RE: **AURORA FOOD STORE**
 2000 ANAQUOD ROAD
 REGINA, SK
 Commission No. 2445

RE: Vestibule Windows

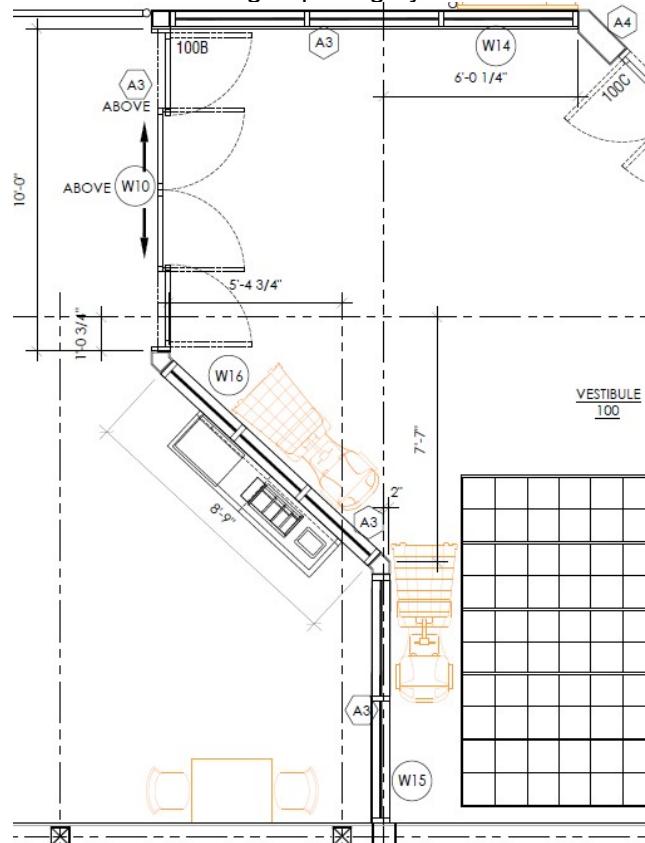
- .1 Reduce width of #W16 rough opening by nine inches from +/- 9' - 6" to be +/- 8' - 9":
